SITE IMPROVEMENT PLAN

SUBLOT NO. 2 IN RIVERWOOD SUBDIVISION AS RECORDED IN VOLUME 27, PAGE 28 OF THE LAKE COUNTY MAP RECORDS. NOW IN THE...

TOWNSHIP OF PERRY, COUNTY OF LAKE AND STATE OF OHIO.

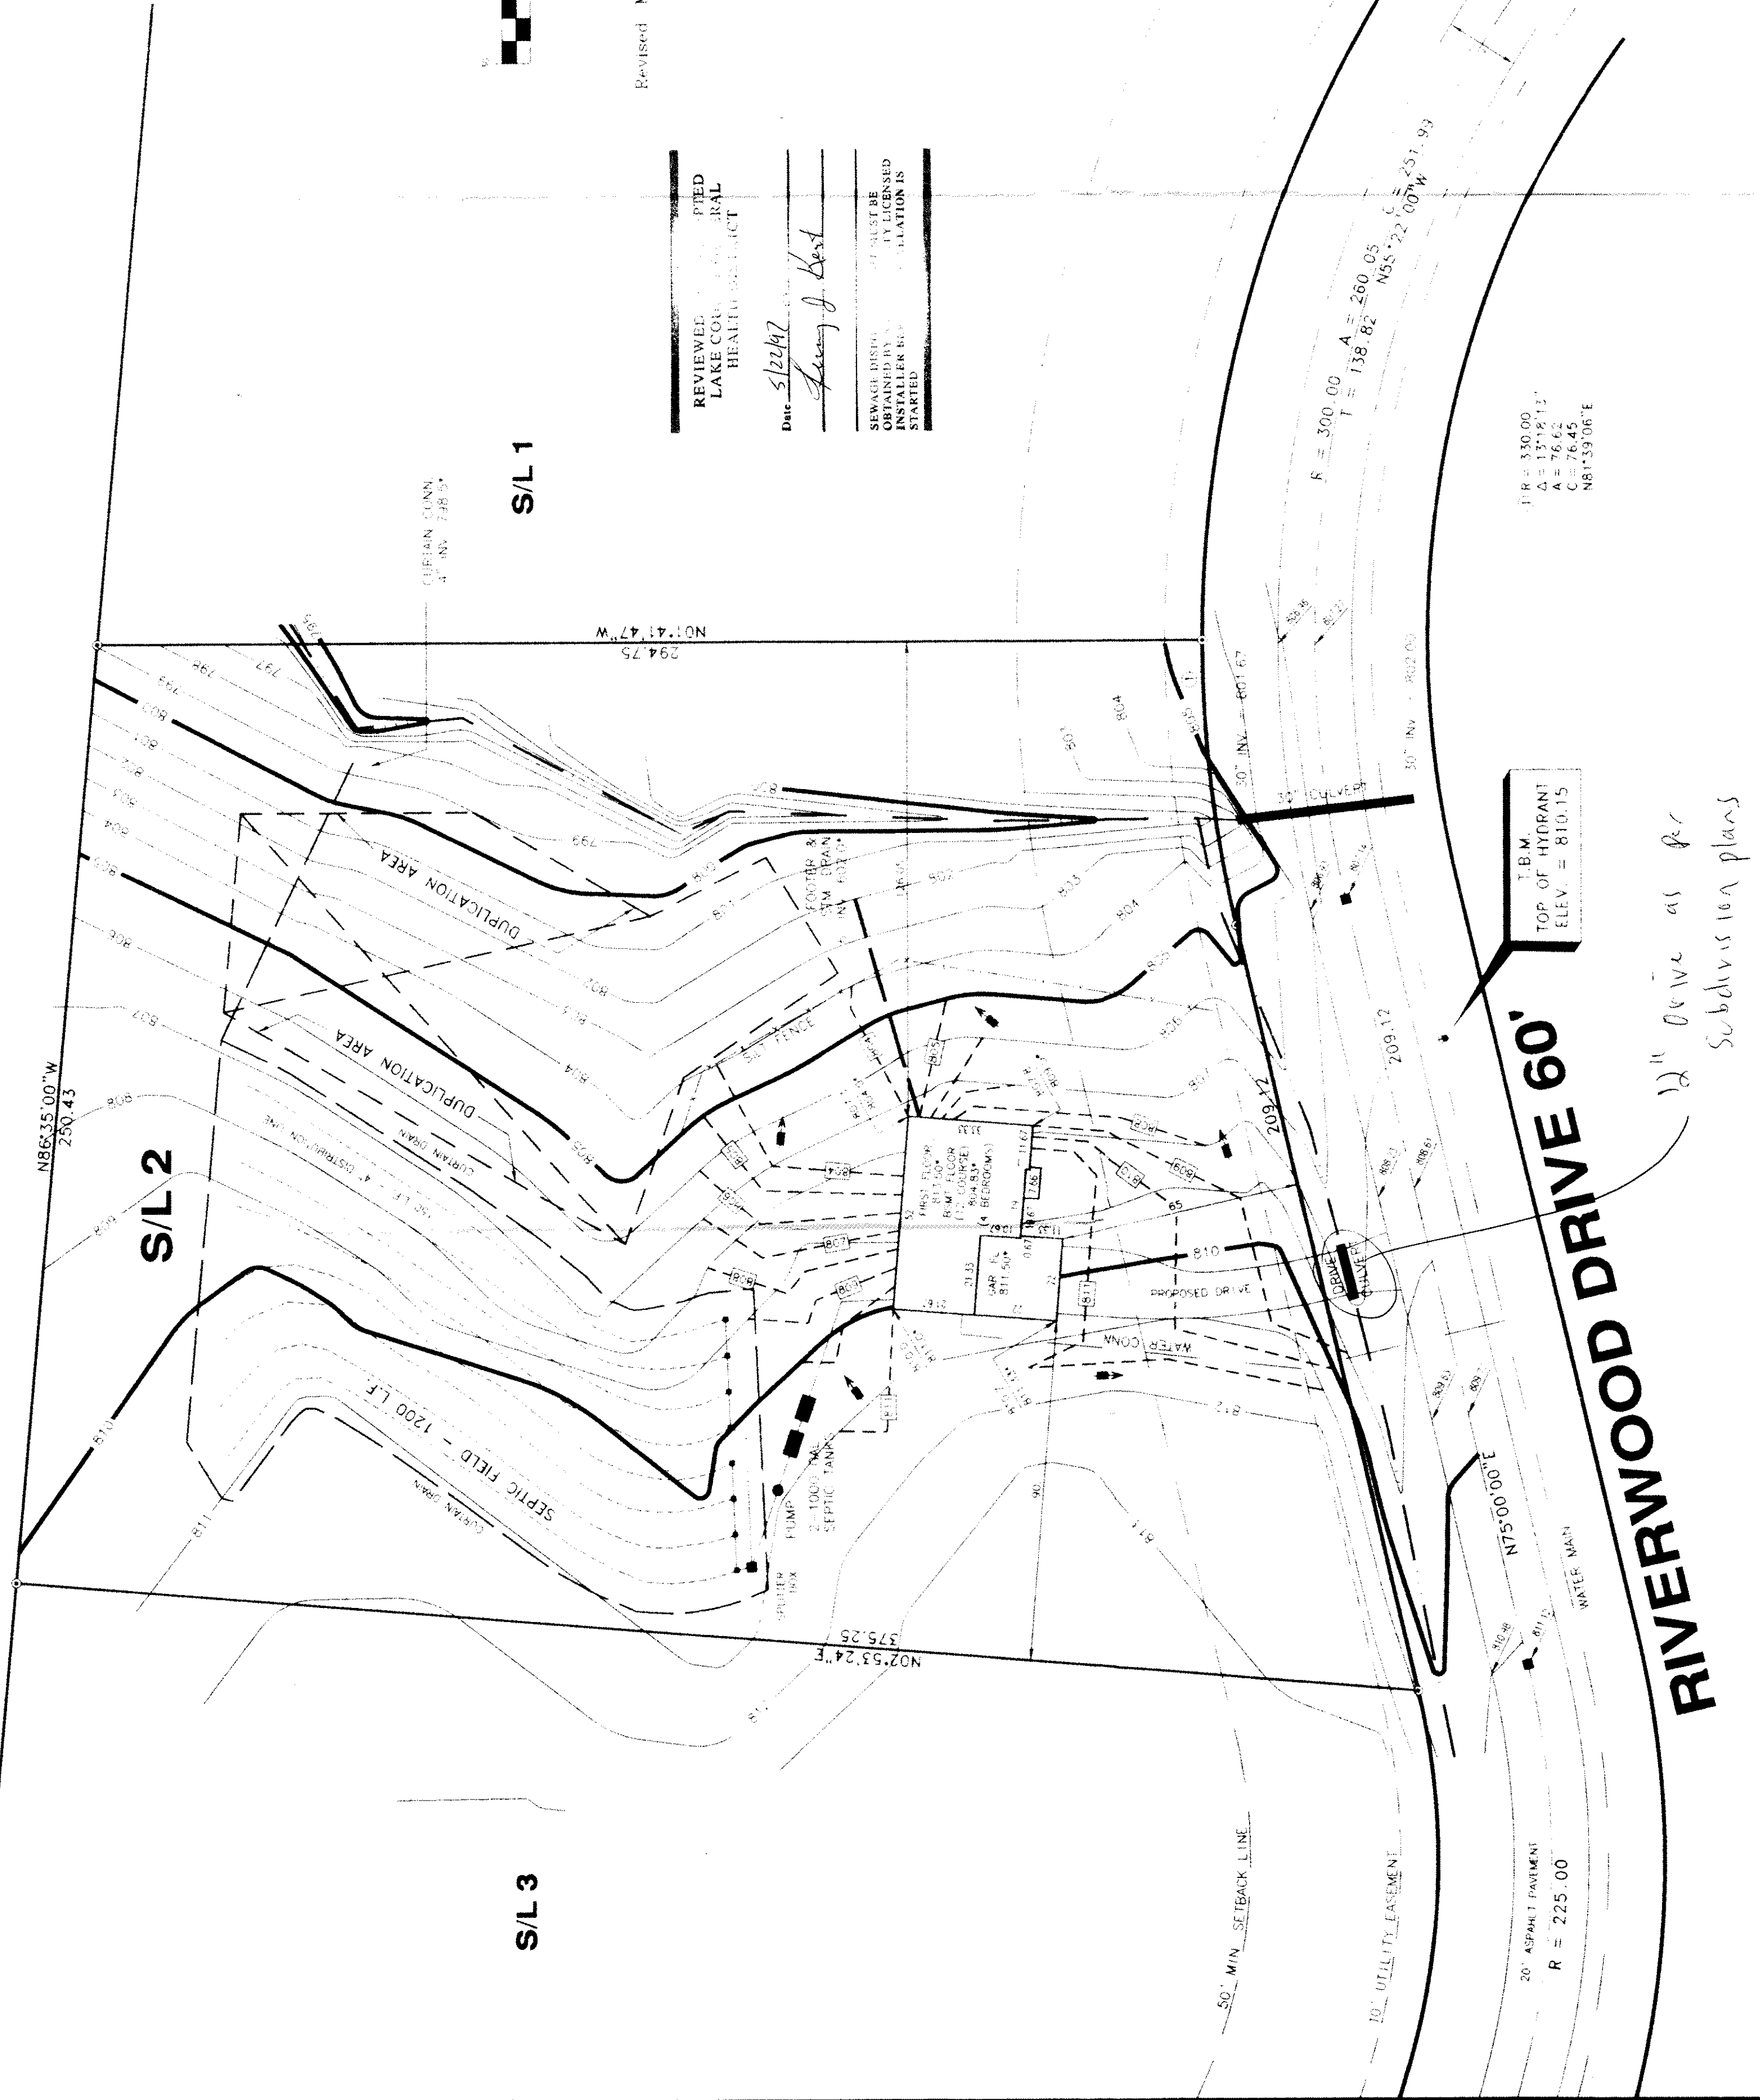
By 6/14 Date 6-6-97
Drive culvert to be installed as per subdivision plans

NOTE: The curtain drain must be 6" deeper than the deepest 6" leaching trench bottom.
